APPENDIX D – MODEL DOCUMENTATION REPORT

**Modeling Documentation
Report: S190 Operations
Study**

**US Army Corps
of Engineers** ®
Jacksonville District

Figure 3. PC-17A Structure flow discharges for HW stages from 17.50 to 18.58 ft NGVD and different TW stages (SFWMD, 2010).

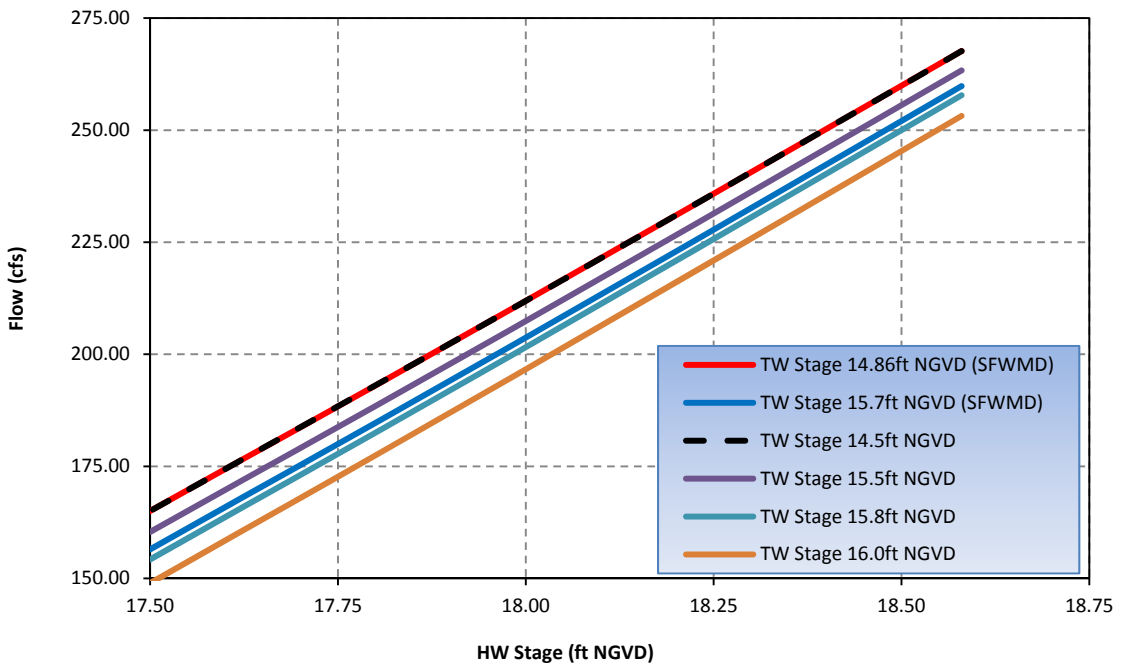
Comment No.	Comment	Reviewer	Agency	Office Symbol	CESAJ-EN-WI Response	Page No.	Critical/non-critical	Done
1	Define Q(T0970) and why is it only referenced in Figures 3 and 4?				Noted. Q(T0970) is a place holder that should have been changed. This notation is actually the flows at the G108 Structure using flow information from DBKEY T0970 in the DBHYDRO database. It is referenced only in figs 3 and 4 because these figures are for hydrographs for 2003 and 2005 when the G108 was in existence. G108 was removed in 2009.	10	NC	Done
2	Include a list of Acronyms (i.e. ft = feet, NGVD 29 = National Geodetic Vertical Datum 1929, cfs = cubic feet per second, etc.)	Nassuti, Melissa A.	USACE	CESAJ-PD-ES	Noted.	iv	NC	
3	Explain how the tested alternatives were chosen, especially Alternatives 3 and 4.	Weston, David M.	USACE	CESAJ-OD-MW		5, 21	NC	Done

Comment [LM9]: What about the impact of whether the 3' boards were in or removed on PC17A's discharge capacity? The board positions were different each year of the 6 years in the analysis...I will add charts in Figures 3+.	Seminole Tribe	STOF	STOF	Not necessary to address boards removed or in place.	11	NC	Done
